Answers to Referee 1

Answers to Referee 2

Fig. A. Left panel: FIRMOS spectra selected in the presence of clear sky. Right panel: backscattering lidar signal corresponding to the FIRMOS measurements time.

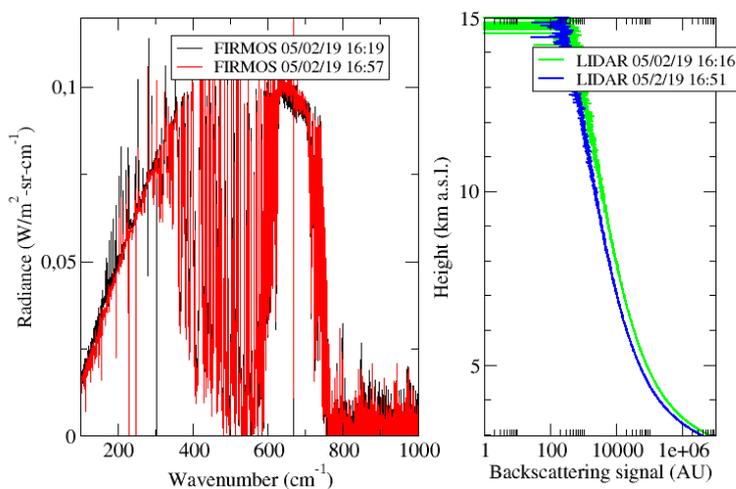
Line 279: In the selection of the 625 cases, did the Raman lidar (or the backscatter lidar, which was briefly mentioned later in the paper) confirm that these were cloud-free?

Yes, the backscattering lidar shows that in case of spectra selected as clear (analysable by KLIMA), no clouds occurred, on the contrary they occurred in case of spectra selected as cloudy (not analysable by KLIMA). In Fig. 1 are shown two FIRMOS spectra selected by the algorithm as clear sky (left panel) and the backscattering lidar signal (right panel) confirms the absence of clouds.

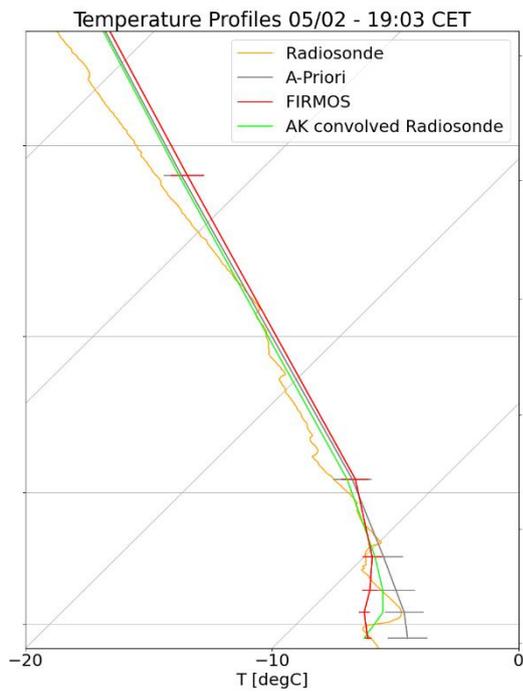
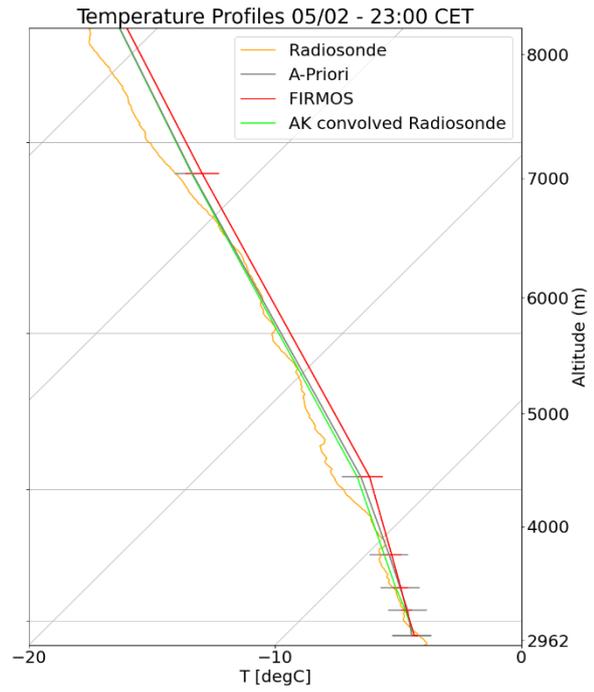
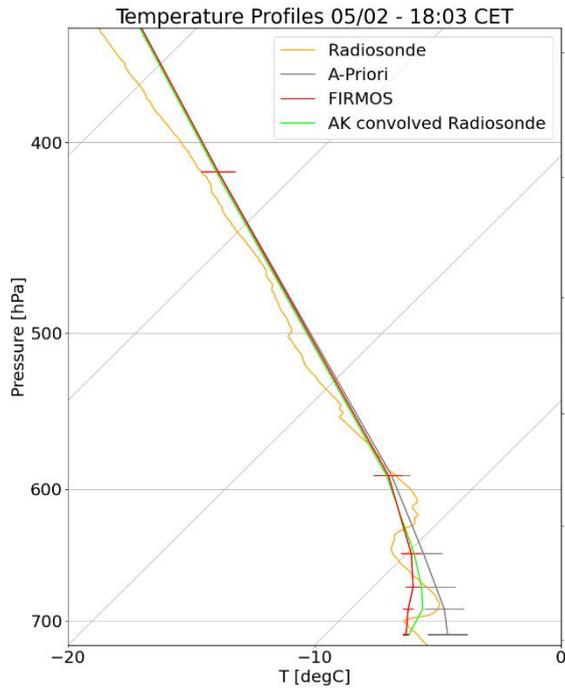
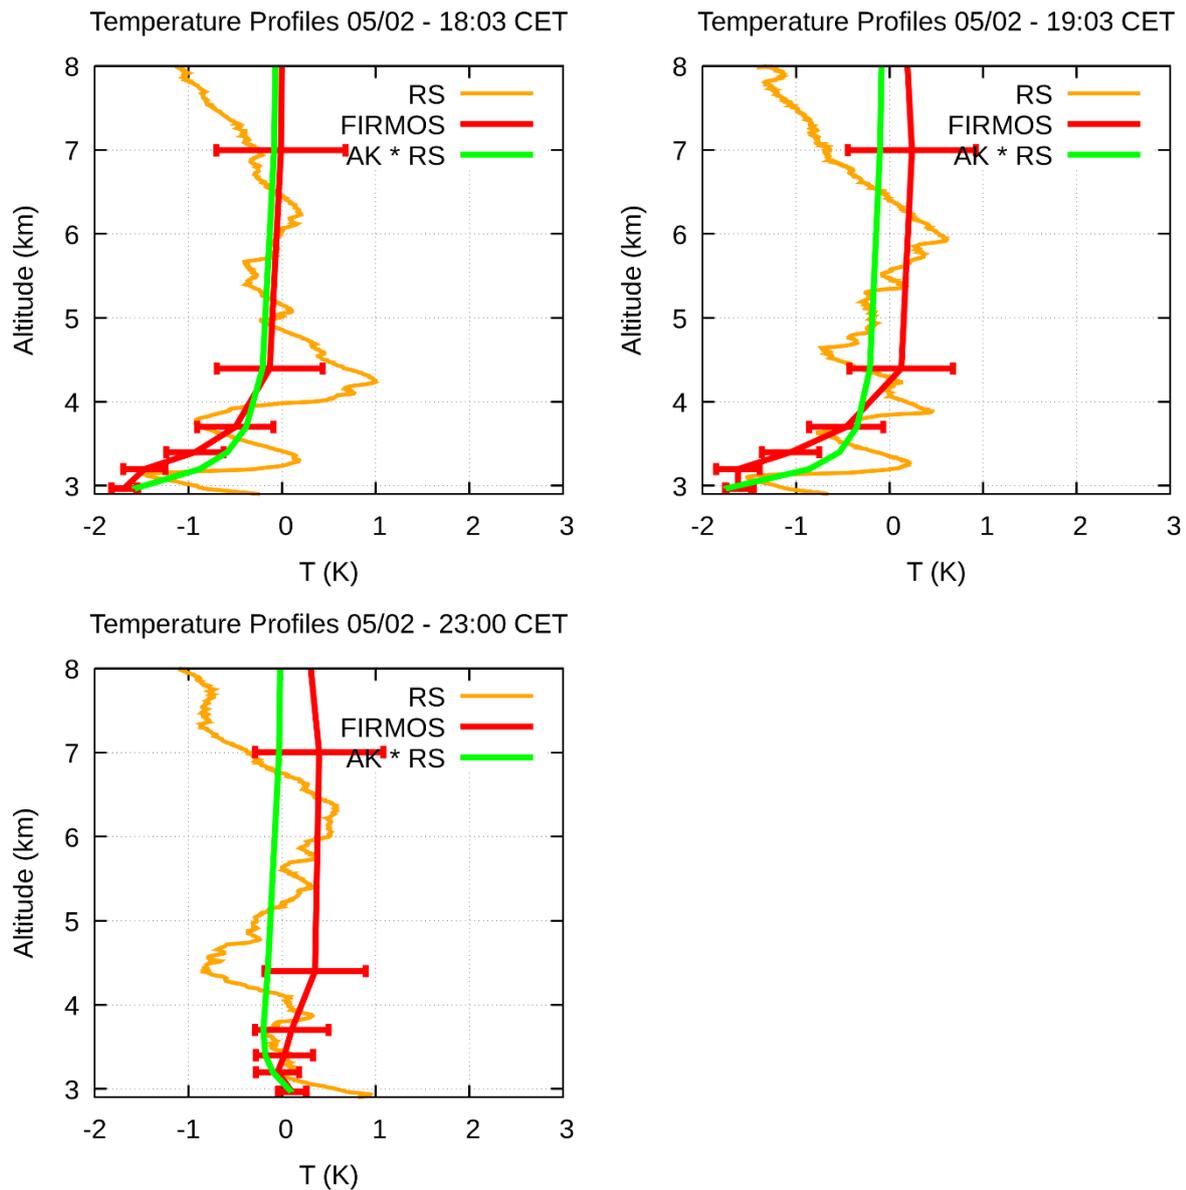
Figure 20: please replot using a skew-T approach, so that differences of a few degrees can be more easily identified and quantified.

The following are the T profiles using skew-T

Referee2 suggested to plot the T profiles as difference. The following plots show T profiles as difference wrt the a-priori ($\hat{x} - x_a$).

We think the difference plots are more intuitive, and clearly show the FIRMOS T profile and the AK convolved Radiosonde are within the retrieval error.

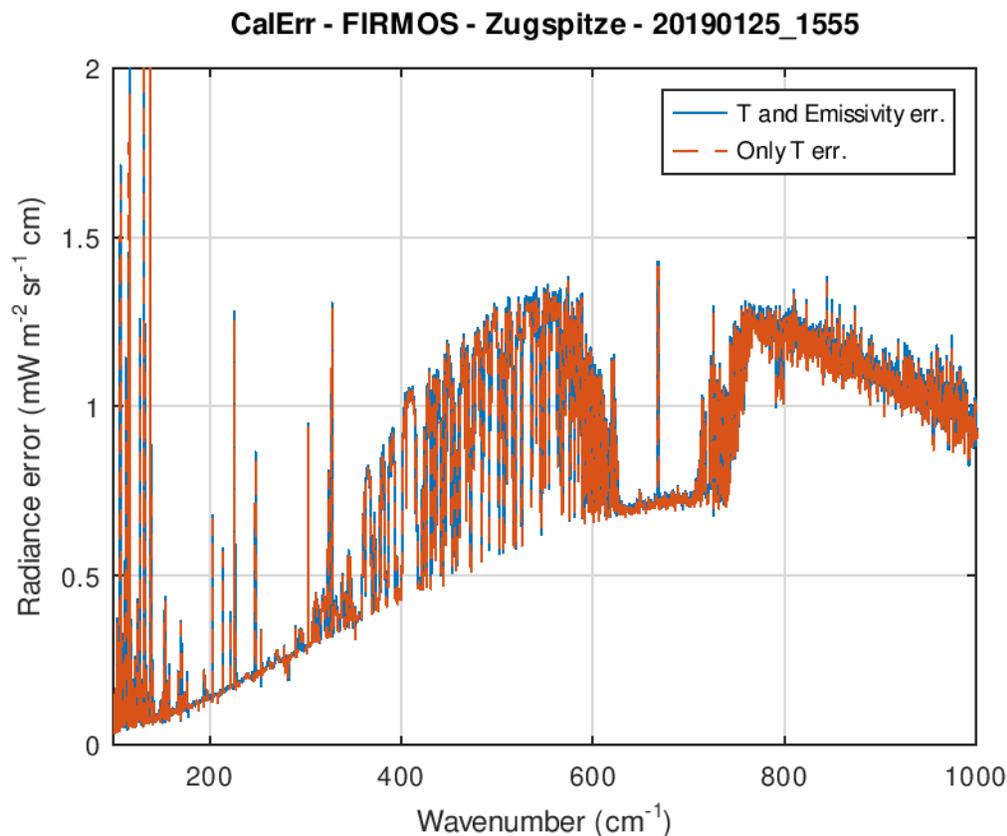
5) I am also missing a comment on the emissivity of the blackbodies. How is a deviation from 1 handled?

The emissivity of the BBs used in FIRMOS is better than 0.9985. The effect of the deviation from one in the emissivity is negligible with respect to the error (300 mK) due to the thermal gradient. The following plot shows in blue the CalErr considering both the emissivity deviation from 1 and the 300mK error on T. The other curve is for the T error alone.

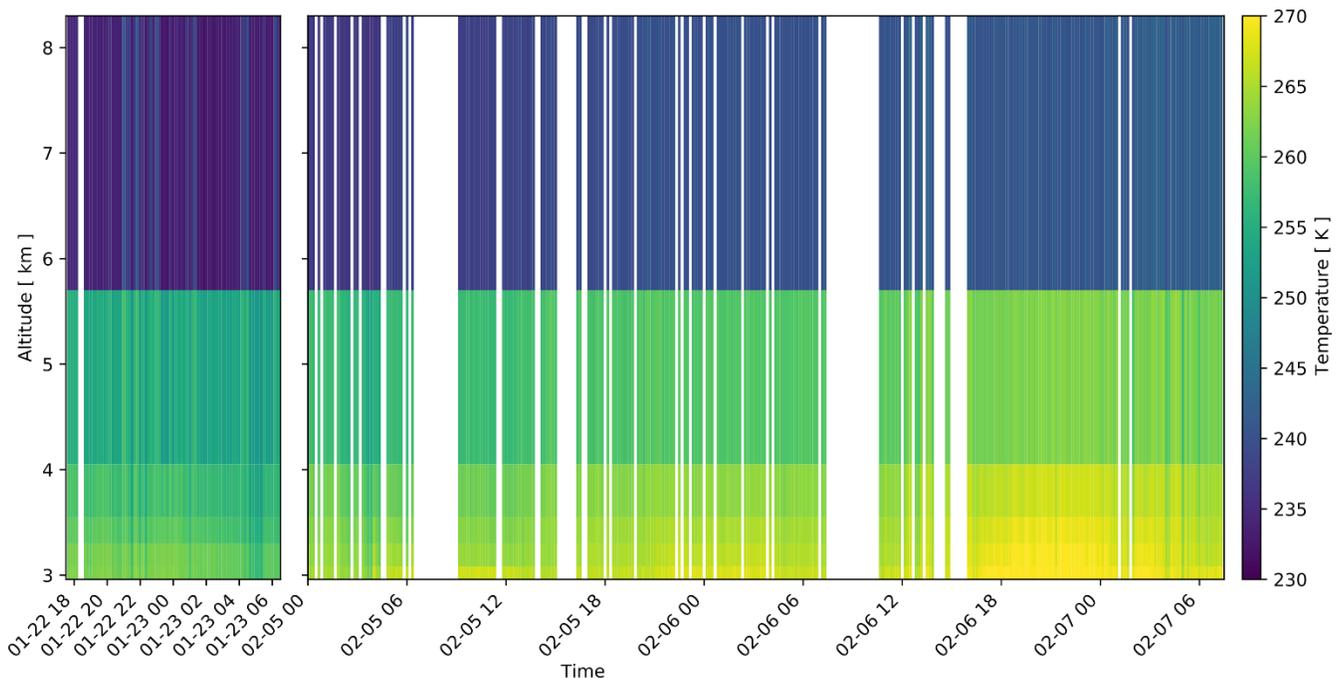
In this section, I find a thorough analysis of the data in terms of fit quality and vertical resolution, but I am missing the data itself, except for two exemplary profiles. Having 625 clear sky profiles in total, it should be possible to provide a meaningful 2D plot as time series (like in Fig. 23) for both water vapour and temperature, when cutting out the times without measurements. This would give an overview over the actual measurements and would allow the reader to comprehend the statement that the variable number of DOFs in water vapour is related to the form of the vertical profiles.

Unfortunately, the data gathered during the campaign is too discontinuous and not dense enough to satisfactorily present the entire dataset. We moved the time-series to section 4.1, the figure is at a higher time-resolution (10 mins) but on the two same periods (22-23 Jan and 5-7 Feb) when measurements were regular enough. The ordinate are now in km as the previous figures.

We removed the qualitative comparison with the ERA reanalysis (see our response to Ref1). The temperature time-series is not particularly informative (see plot below) and we don't think it should be added to the paper.

correlation T DoF vs meanNESR (560-800 cm-1)

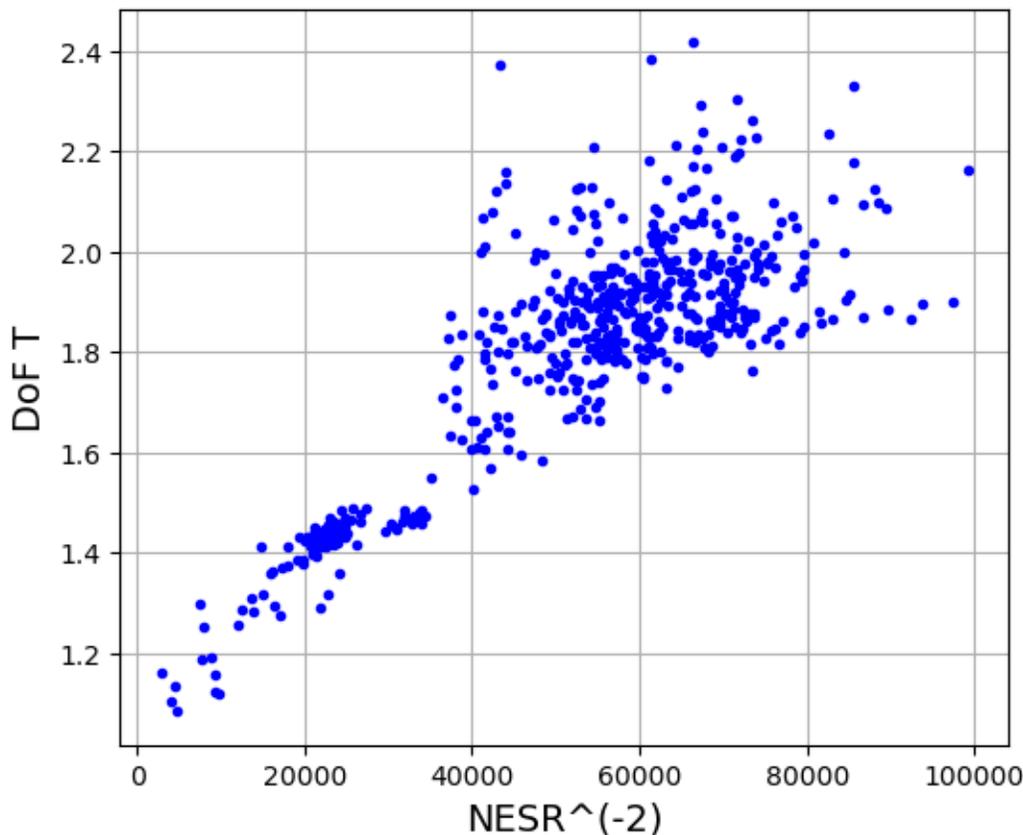
Fig. 14: Also the temperature shows a certain variability in the number of DOFs, although less pronounced than for water vapour. Do you have an explanation for this variation? Is it also related to the actual profile?

We find that the number of DOFs for T is perfectly correlated to the the inverse of NESR (see the following plot).

"The variation in the number of DOFs for the temperature profile is due to the variation of the FIRMOS NESR, indeed, a perfect correlation between the number of DOFs and the average of the inverse of the FIRMOS NESR was found".

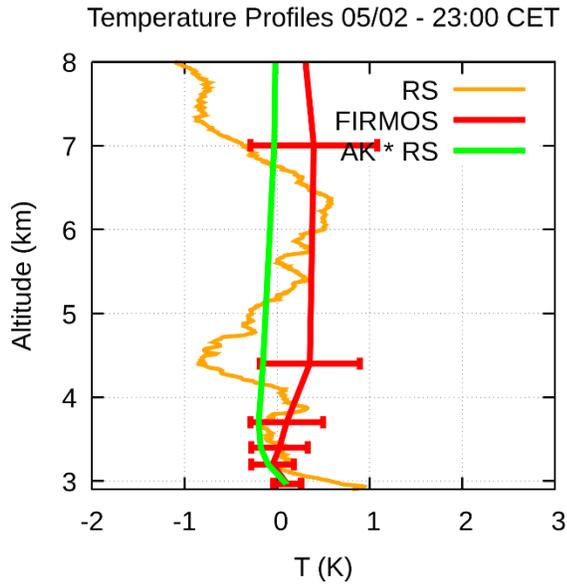
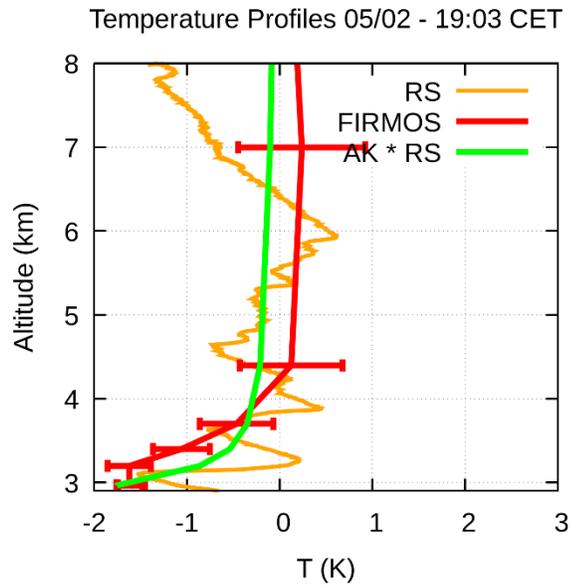
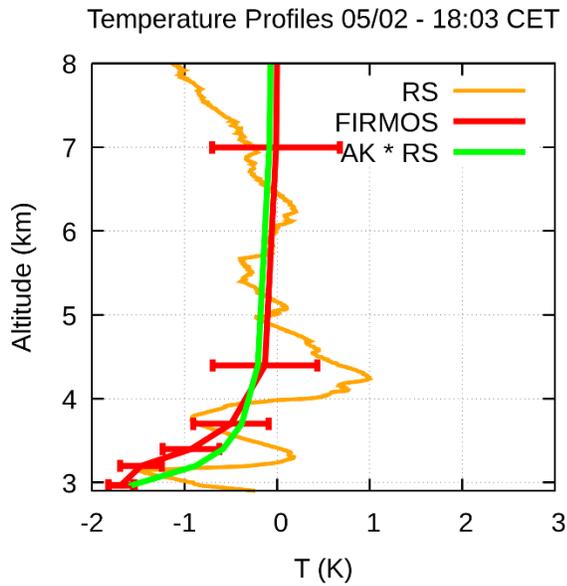
Fig. 20: Difference plots would be helpful here.

The following plots show T profiles as difference wrt the a-priori ($\hat{x} - x_a$).

Referee1 suggested to use skew-T plots here, we think the difference plots are more intuitive, and clearly show the FIRMOS T profile and the AK convolved Radiosonde are within the retrieval error.
